DEVELOPMENT REVIEW BOARD
SUPPLEMENTAL SUBMITTAL

PROJECT NO. 2022-006547

DESCRIPTION: DRB - Site planning 2nd resubmittal city comments response

RE: Panda Express – S8-22-D8582
10126 Coors Blvd. NW
Albuquerque, NM 87114
RE: DRB Planning Review – 2nd Resubmittal
DRB Project Number: 2022-006547
App. Number: SI-2022-00216

SOUTH-WEST ELEVATION 3
Scale= 3/16" - 1/0" A-202

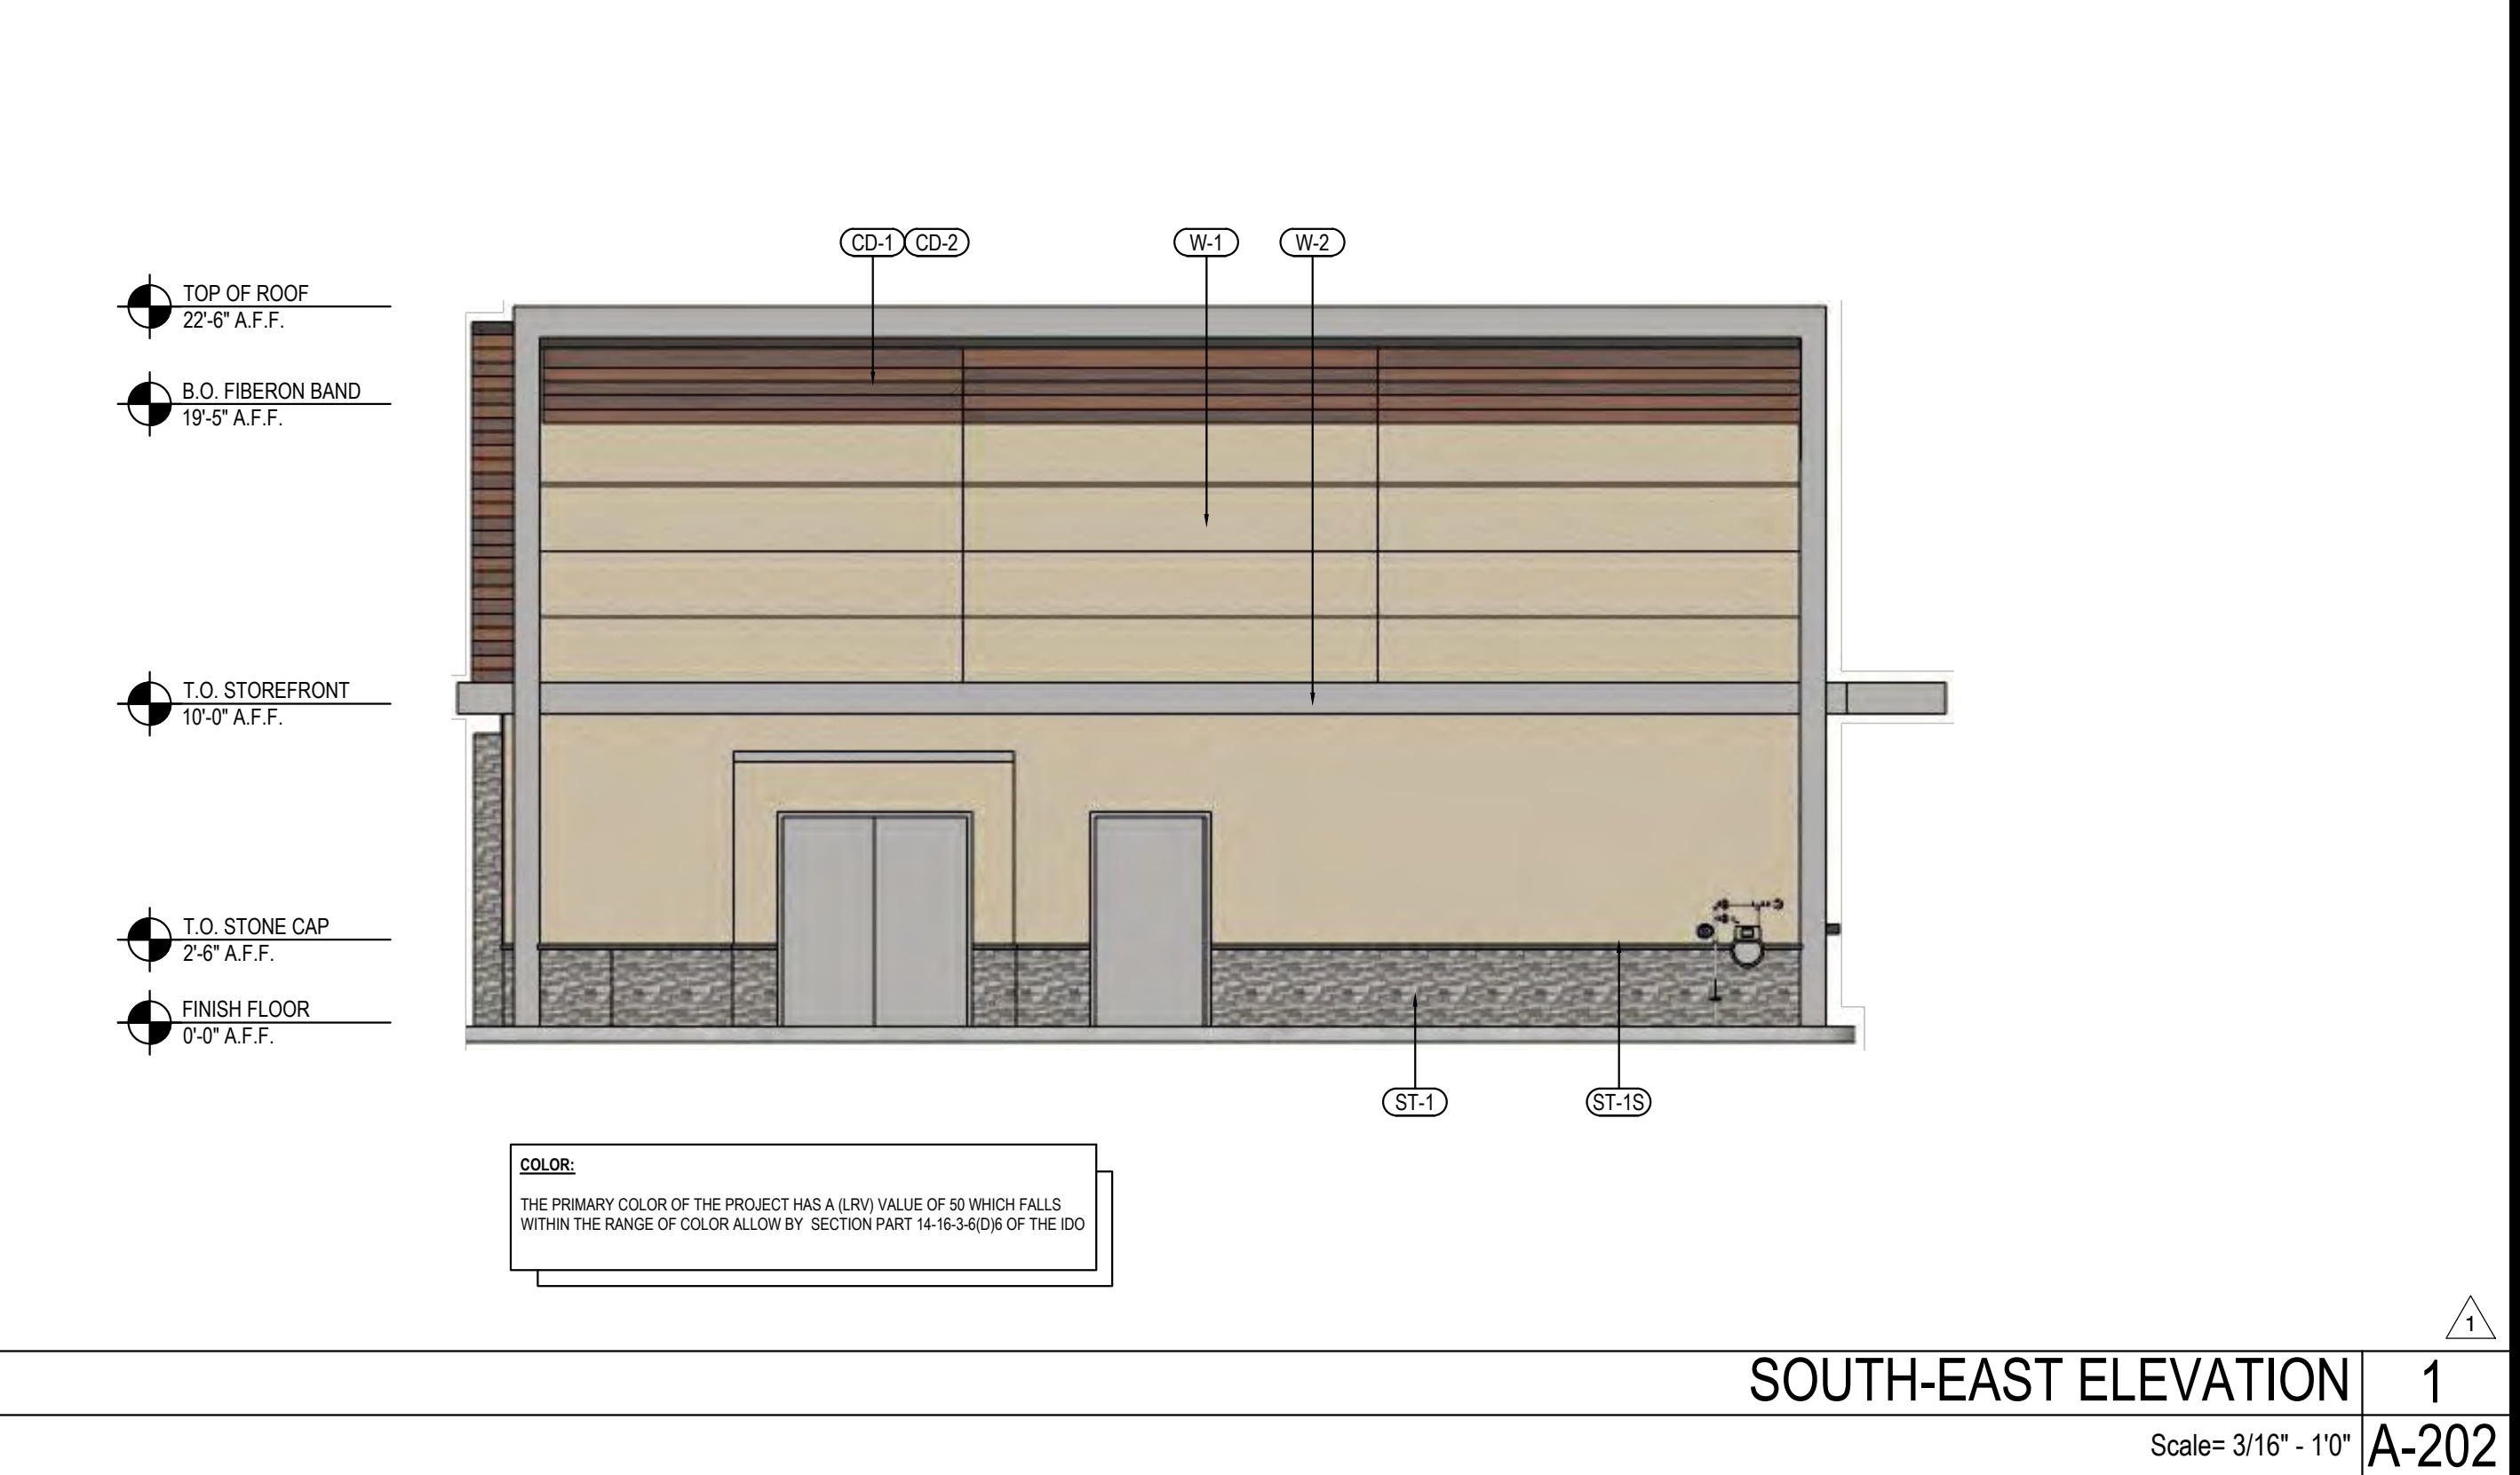
- The % of the façade taken up by the wall signage must be included.
Response: Refer to sheet A-202 for the percentage of façade the taken by the wall signage. See detail 2/A202 for the Northwest elevation signage is 3.4%, detail 4/A202 for Northeast elevation signage is 2.5% and detail 3/A-202 - Southwest elevation signage is 2.5%
